Special Bulletin

SP15-336C

FIVE FOOT SWITCHES REPLACEMENT

Prevost vehicles

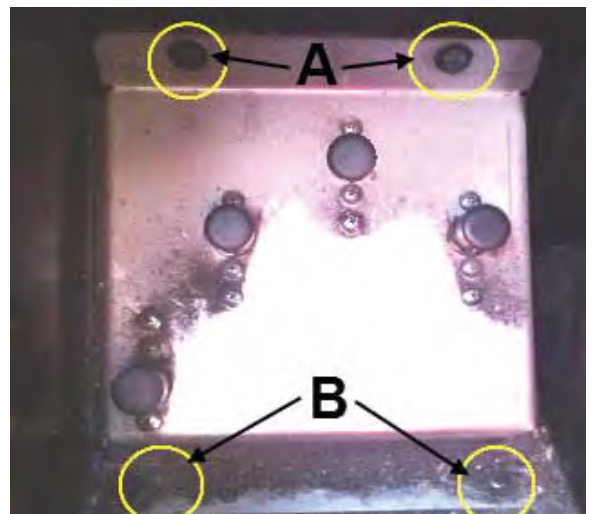
Revision C: This document supersedes previous revisions.
 Added specific torque value at step 9 (part 1) and step 5 (part 2) for bolts fastened to the floor (plywood).

- 9) Finally, reinstall the switch pedestal in original position.

Bolts A: standard torque: 18 lbs-ft
Bolts B: specific torque: 7 lbs-ft

Apply torque seal on bolts B

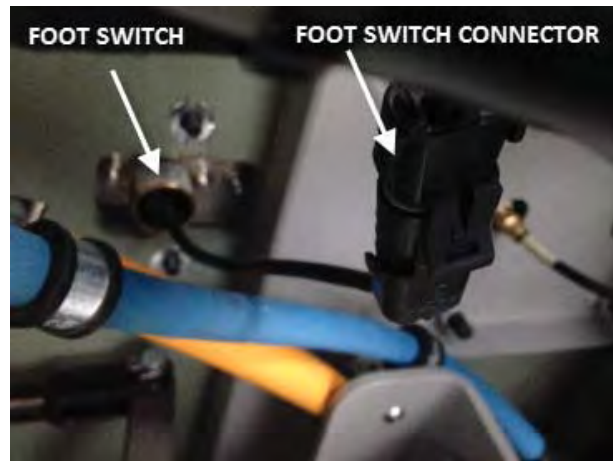
- 5) Reinstall the circular mounting place (**torque: 7 lbs-ft**). Apply torque seal.
- 6) Underneath the floor, plug the new switch connector.
